Applicant Responses to Select Public Comments on the Draft Proposed Order

Boardman to Hemingway Transmission Line Project
Idaho Power's Responses to Public Comments Received by ODOE on the Draft Proposed Order
October 16, 2019

**Attachment 4: Boardman to Hemingway Transmission Line
 DPO Comment, Applicant Responses, Department Response in Proposed Order Crosswalk Tables**

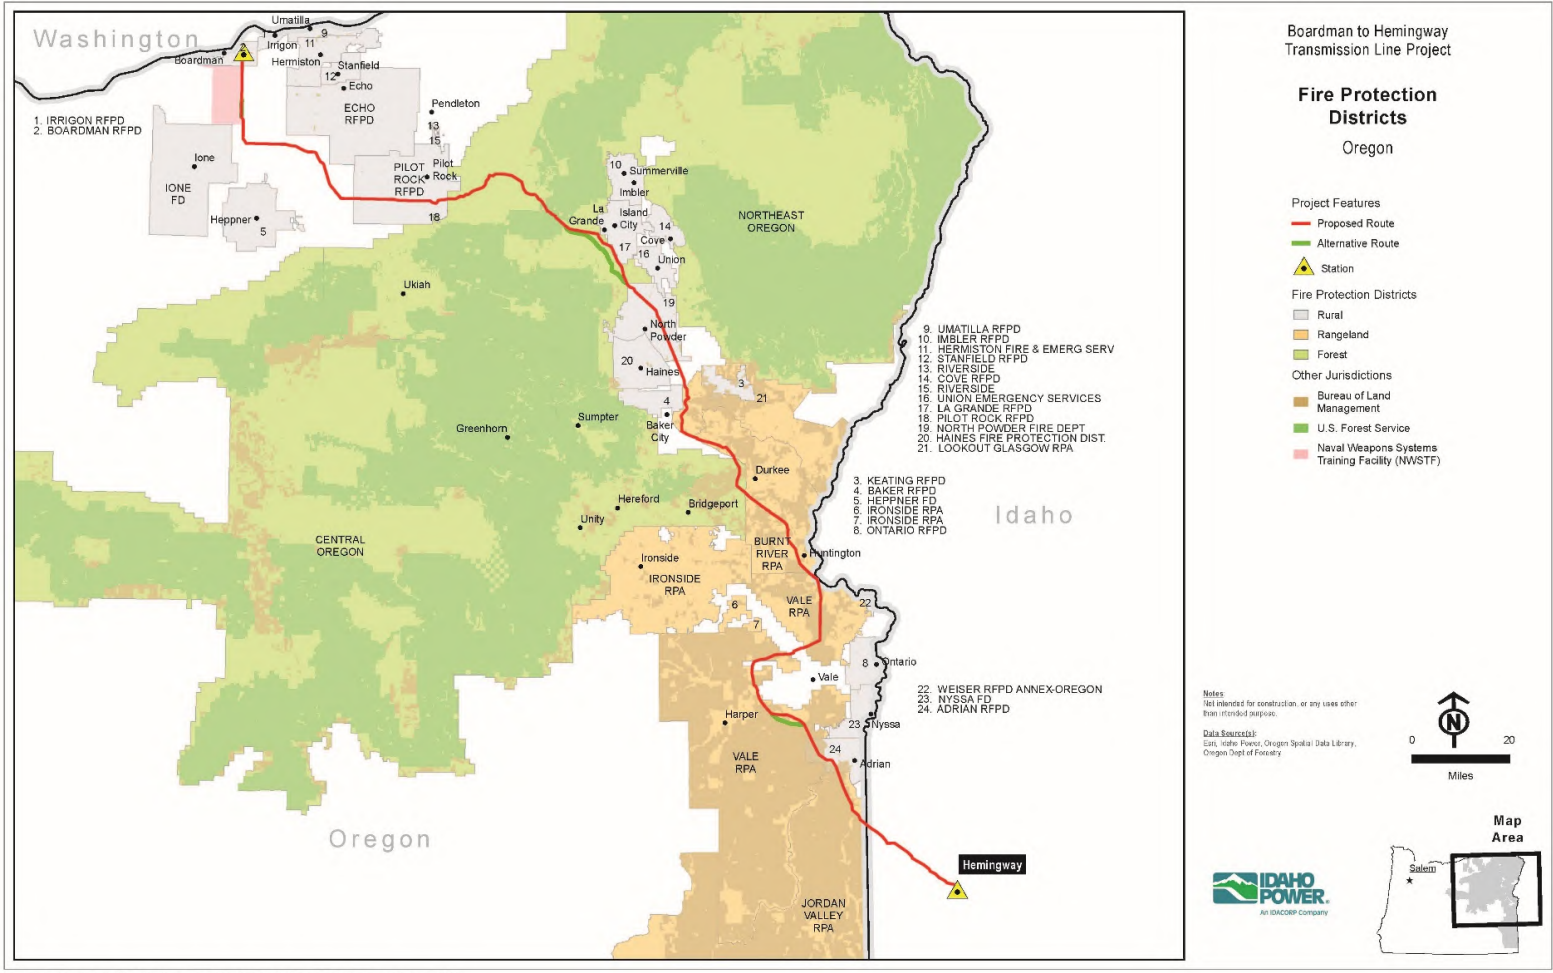
<p>available. Lines 2-8 on page 508 state that lands that are not within a fire district will be covered by mutual aid. While that may be true under ideal circumstances, in areas outside of a fire district or association, there is no guarantee of fire response. Mutual aid agreements as used in this context are between two fire response organizations who have like resources to ' trade ', they are not made to cover lands that don't fall within any jurisdiction's response territory. The assumptions made in the ASC are therefore not accurate, and cannot be utilized to demonstrate compliance with the public services standard because they do not accurately account for the project's impact or the reality of fire response in the project area. Baker County disagrees with the statement that the project will not have significant impacts on fire protection services. The DPO describes precisely why the fire protection impact is significant - most construction will occur during hot and dry weather, when fire risk is highest, in grassland and shrub-dominated landscapes particularly vulnerable to fire. Project construction involves many potential fire-inducing activities including use of motorized vehicles and equipment, welding, refueling and smoking. As we know from the last few summers, fire risk is already elevated in eastern Oregon even without introducing increased fire hazards into remote areas. Given the high fire risk and the minimal available public services, IPC needs a more robust Fire Prevention and Suppression Plan. IPC needs to be required to provide meaningful mitigation for the impact, such as a full complement of fire protection equipment and trained firefighting personnel on site during construction, as well as an emergency plan coordinated with the County Emergency Management staff. This plan must be coordinated with the County and fire response agencies. IPC has committed to working with the County on this matter, and the County requests this be included as a condition.</p>	<p>in the event of a fire. To clarify those points, Idaho Power has provided the map and table below, demonstrating that the vast majority of the transmission line will be located either within the boundaries of a local fire response organization or on federal land where fire response is managed by BLM or the Forest Service. In those areas covered by a fire response organization or located on federal land, Idaho Power will attempt to negotiate an agreement with the relevant fire response organization or federal agencies, outlining communication and response procedures for potential fires within their boundaries (those agreements are not considered "mutual aid agreements," as mentioned by the county). In those areas not covered by a fire response organization and not located on federal land, Idaho Power will attempt to negotiate an agreement with nearby fire response organizations or the federal agencies to provide fire response. If no such agreements can be reached, Idaho Power will propose alternatives such as contracting with a private fire response company or providing additional firefighting equipment at those sites.</p> <p>Further, to address the county's concerns about coordination on the final Fire Prevention and Suppression Plan, see response above where Idaho Power proposes adding condition language providing the counties at least two opportunities to review and comment on the plans prior to Idaho Power's submittal of the plans to ODOE and committing Idaho Power to provide written responses to any comments received from the counties.</p>

Commenter	Comment	Idaho Power's Response
Malheur County	I. Page 35, Line 22 discusses the prevention and suppression of wildfires in eastern Oregon, designating the task to BLM, USFS, and local fire districts and agencies. The majority of B2H is not located in a local fire district (see Attachment 1) in Malheur County. Instead, the wildfire suppression would be performed by BLM with the cooperation of the designated Rangeland Fire Protection Associations (RFPA) (see Attachments 2 & 3). Malheur County would like to see a Condition of Approval which would direct the Applicant to coordinate with the local RFPA's for wildfire prevention and suppression.	To address the county's concerns and to clarify Idaho Power's plan for ensuring that adequate fire response procedures are in place in the event of a fire during construction, Idaho Power has provided the map and table below, demonstrating that the vast majority of the transmission line will be located either within the boundaries of a local fire response organization or on federal land where fire response is managed by BLM or the Forest Service. During construction, in those areas covered by a fire response organization or located on federal land, Idaho Power will attempt to negotiate an agreement with the relevant fire response organization or federal agencies, outlining communication and response procedures for potential fires within their boundaries. In those areas not covered by a fire response organization and not located on federal land, Idaho Power will attempt to negotiate an agreement with nearby fire response organizations or the federal agencies to provide fire response. If no such agreements can be reached, Idaho Power will propose alternatives such as contracting with a private fire response company or providing additional firefighting equipment at those sites.

<p>Idaho Power suggests that the Council make the following changes to the fire response discussion to capture the clarifications discussed above:</p> <p><u>The applicant demonstrates that the large majority of the transmission line will be located either within the boundaries of a local fire response organization or on federal land where fire response is managed by BLM or the Forest Service. For construction, in those areas covered by a fire response organization or located on federal land, Idaho Power will attempt to negotiation an agreement with the relevant fire response organization or federal agencies, outlining communication and response procedures for potential fires within their boundaries. In those areas not covered by a fire response organization and not located on federal land, Idaho Power will attempt to negotiate an agreement with nearby fire response organizations or the federal agencies to provide fire response. If no such agreements can be reached, Idaho Power will propose alternatives such as contracting with a private fire response company or providing additional firefighting equipment at those sites. Not all lands in the analysis area fall within a designated fire district. In those cases, the closest or best situated fire district responds to fires. Mutual aid agreements have been established between local fire districts and adjacent counties to pool resources, ensure cooperation between these entities, and respond to fires on a county and state level instead of isolating efforts to local districts. As a result of these mutual aid agreements, the fire district that responds to a fire may not be the district that the fire occurs in, or even the closest district; instead, response is based on the district that is best situated and suited to respond. The applicant provided correspondence summaries with fire</u></p>

<p>departments, rural fire protection districts, and rangeland fire protection associations in ASC Exhibit U, Attachment U-1C. The majority of fire protection providers discussed that the proposed facility would not adversely impact their ability to provide fire prevention services. There were concerns expressed from some fire protection providers that fire districts within the analysis area are comprised of volunteers, so it may take considerable time to collect and mobilize an entire fire crew and that response times to fires in the analysis area vary depending on the time of day, the priority of the emergency/call and the location of the emergency and the type of available access. The Department notes that the response times provided in Table PS-9: Fire Departments, Rural Fire Protection Districts, and Rangeland Fire Protection Associations, are estimates that may not contemplate a busy fire season with longer delays or response times. Addressed below is the discussion of the draft Fire Prevention and Suppression Plan and measures the applicant would be required to take to minimize on-site fire risks and the applicant's ability to provide fire protection measures itself until responders arrive.</p>

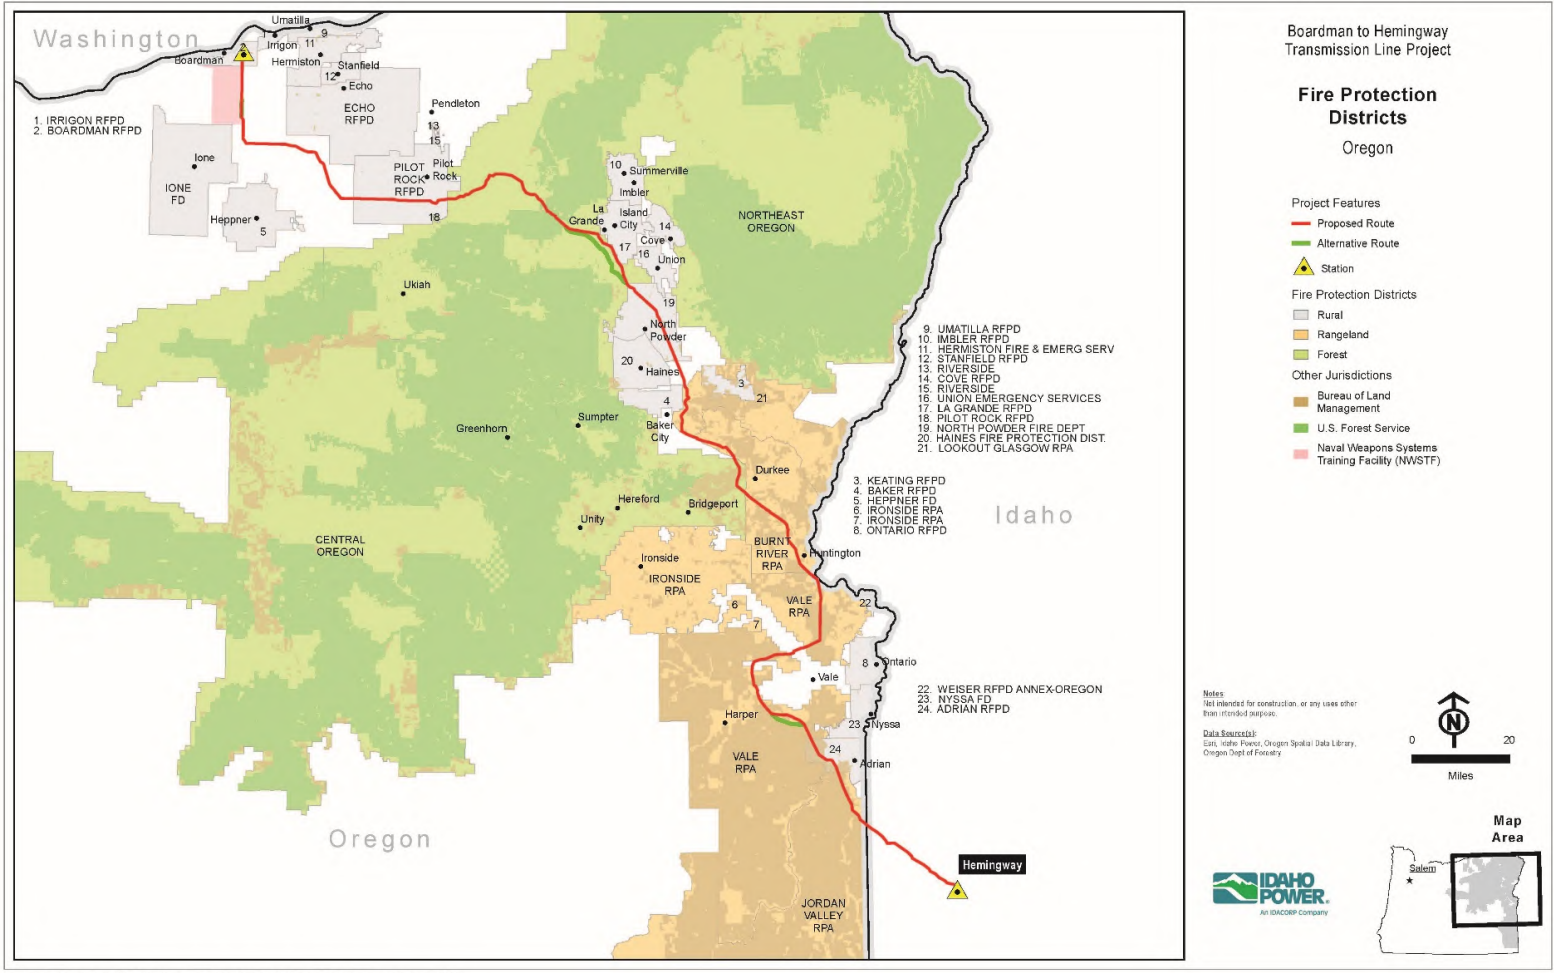
<p><i>Wildland Fire Danger</i> Union County is comprised of terrain that can be challenging to reach by emergency vehicles and during the summer months is usually under a high industrial fire precaution level.</p>	<p>To address the county's concerns and to clarify Idaho Power's plan for ensuring that adequate fire response procedures are in place in the event of a fire, Idaho Power has provided the map and table below, demonstrating that the vast majority of</p>

<p>Idaho Power suggests that the Council make the following changes to the fire response discussion to capture the clarifications discussed above:</p> <p><u>The applicant demonstrates that the large majority of the transmission line will be located either within the boundaries of a local fire response organization or on federal land where fire response is managed by BLM or the Forest Service. For construction, in those areas covered by a fire response organization or located on federal land, Idaho Power will attempt to negotiate an agreement with the relevant fire response organization or federal agencies, outlining communication and response procedures for potential fires within their boundaries. In those areas not covered by a fire response organization and not located on federal land, Idaho Power will attempt to negotiate an agreement with nearby fire response organizations or the federal agencies to provide fire response. If no such agreements can be reached, Idaho Power will propose alternatives such as contracting with a private fire response company or providing additional firefighting equipment at those sites. Not all lands in the analysis area fall within a designated fire district. In those cases, the closest or best situated fire district responds to fires. Mutual aid agreements have been established between local fire districts and adjacent counties to pool resources, ensure cooperation between these entities, and respond to fires on a county and state level instead of isolating efforts to local districts. As a result of these mutual aid agreements, the fire district that responds to a fire may not be the district that the fire occurs in, or even the closest district; instead, response is based on the district that is best situated and suited to respond. The applicant</u></p>

<p>provided correspondence summaries with fire departments, rural fire protection districts, and rangeland fire protection associations in ASC Exhibit U, Attachment U-1C. The majority of fire protection providers discussed that the proposed facility would not adversely impact their ability to provide fire prevention services. There were concerns expressed from some fire protection providers that fire districts within the analysis area are comprised of volunteers, so it may take considerable time to collect and mobilize an entire fire crew and that response times to fires in the analysis area vary depending on the time of day, the priority of the emergency/call and the location of the emergency and the type of available access. The Department notes that the response times provided in Table PS-9: Fire Departments, Rural Fire Protection Districts, and Rangeland Fire Protection Associations, are estimates that may not contemplate a busy fire season with longer delays or response times. Addressed below is the discussion of the draft Fire Prevention and Suppression Plan and measures the applicant would be required to take to minimize on-site fire risks and the applicant's ability to provide fire protection measures itself until responders arrive.</p>

Figure 3 – Viewshed of ML 8/2

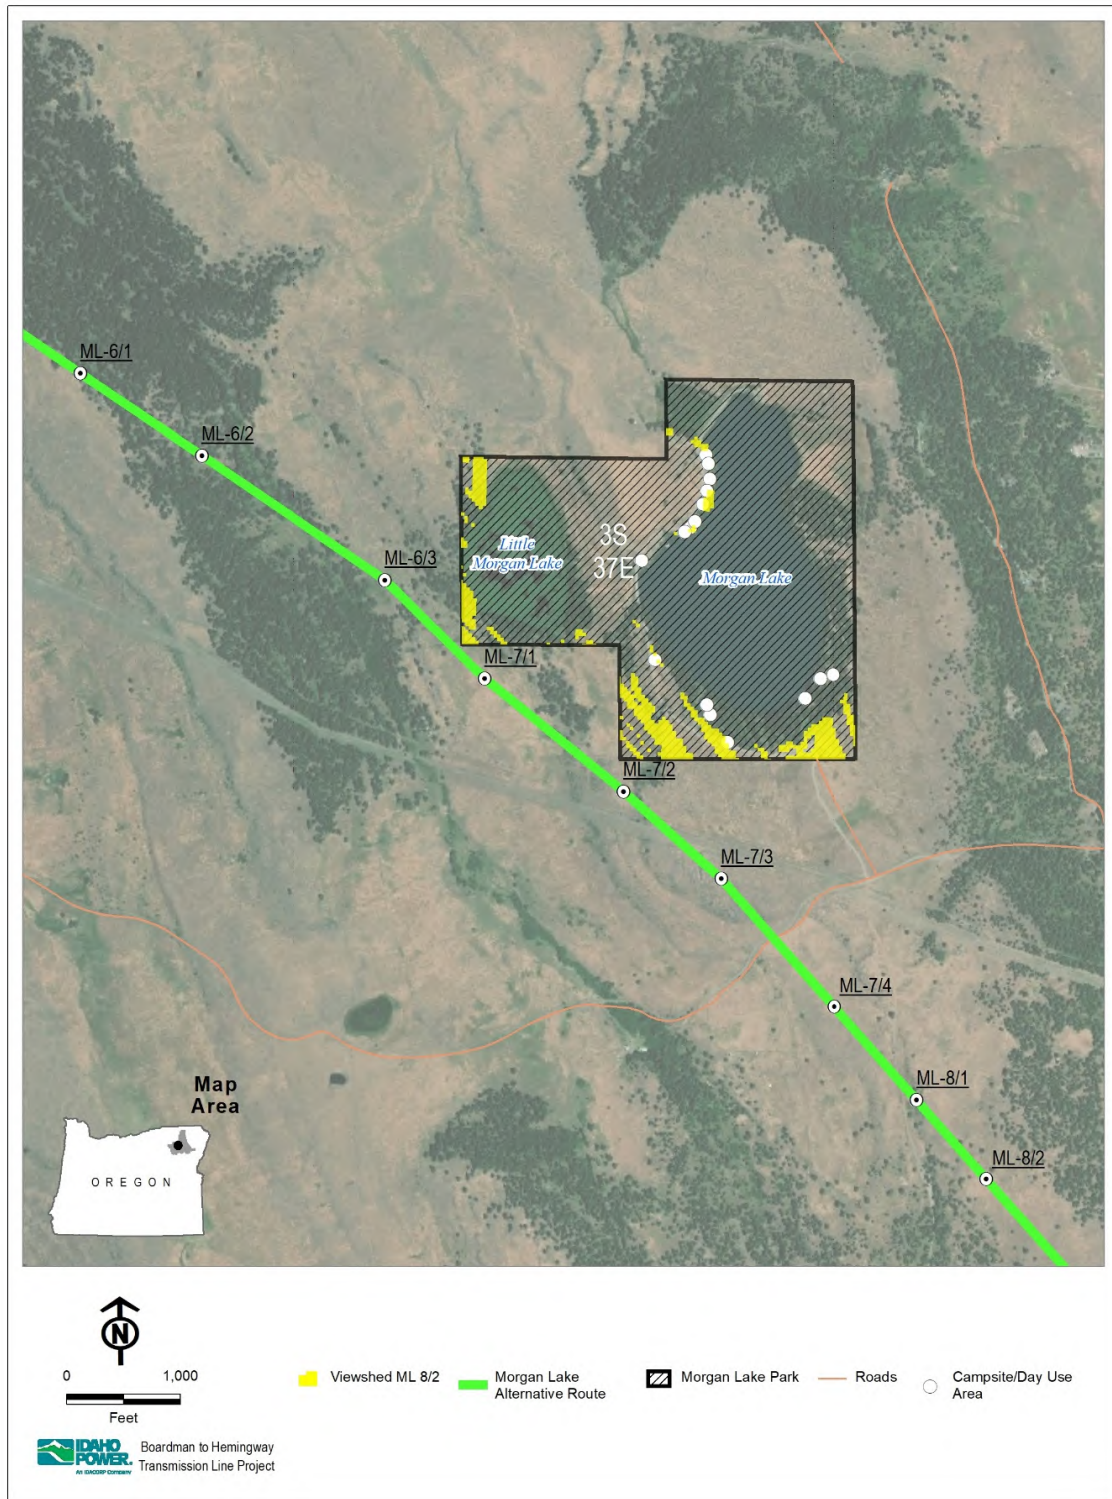
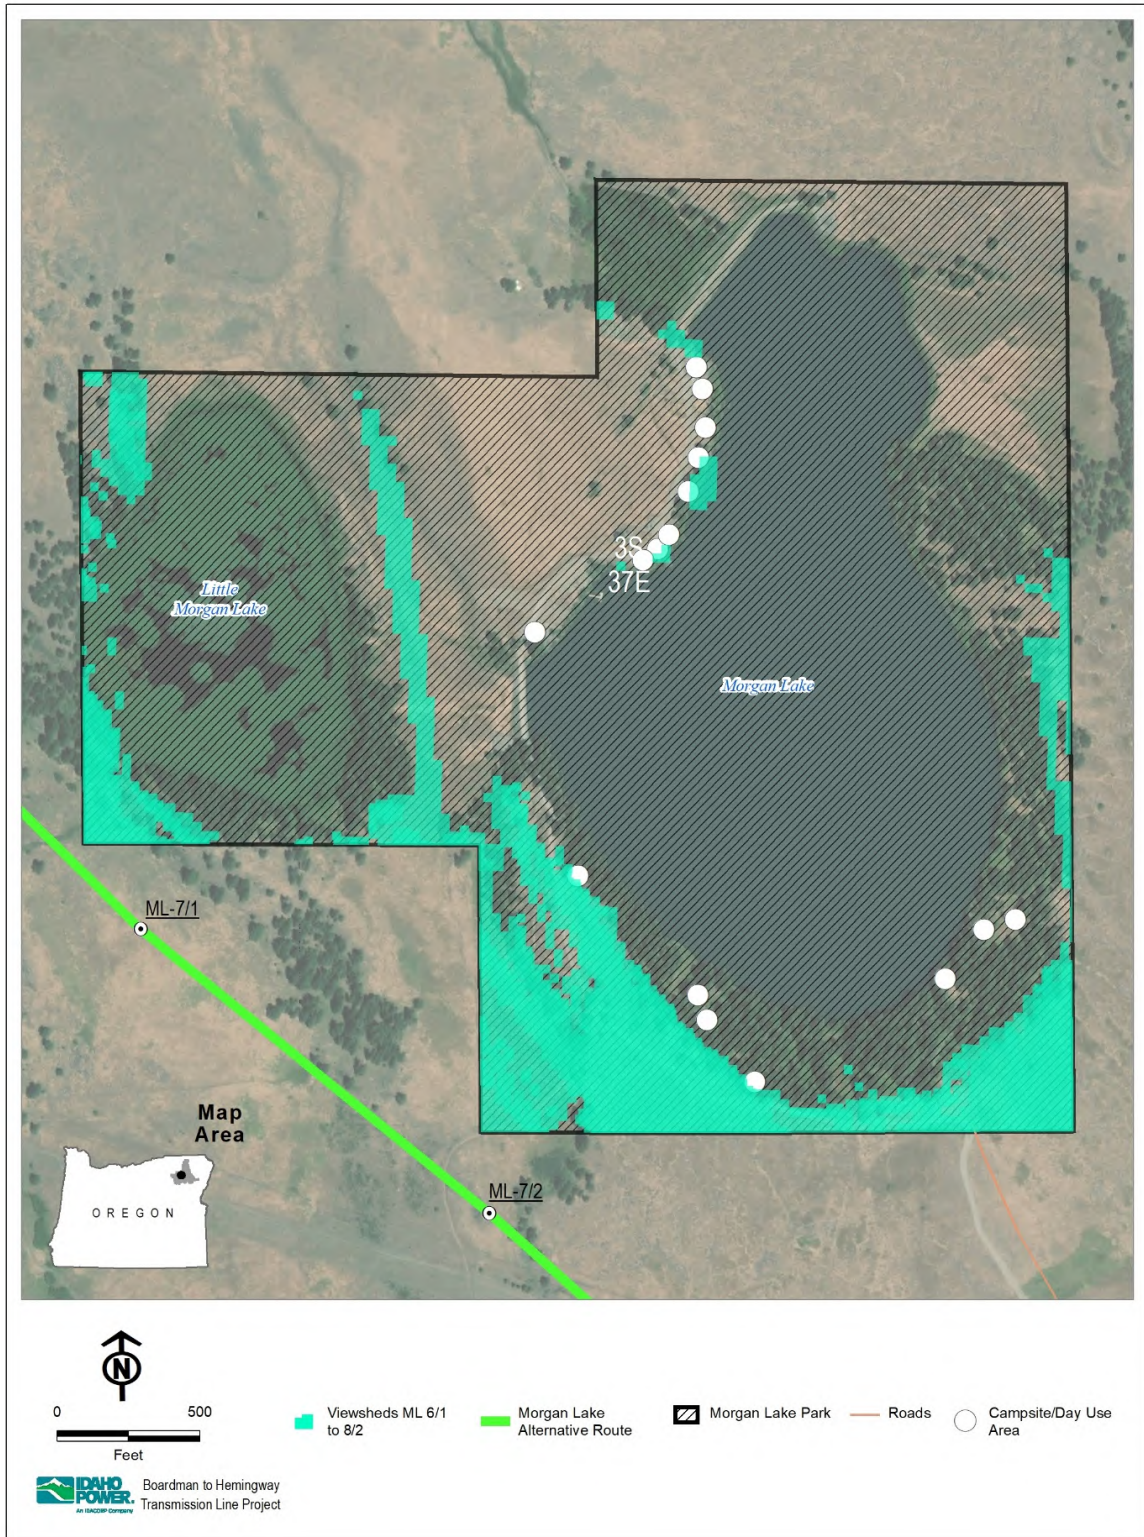
Around Morgan Lake, vegetation would effectively screen views of the transmission towers except for a few discrete locations along the western shore. No towers would be visible from the floating dock (see Figure 3 and Figure 8). Towers would not be visible from the campsites themselves along the southern shore of Morgan Lake, although the towers would be visible from the campsite parking areas.
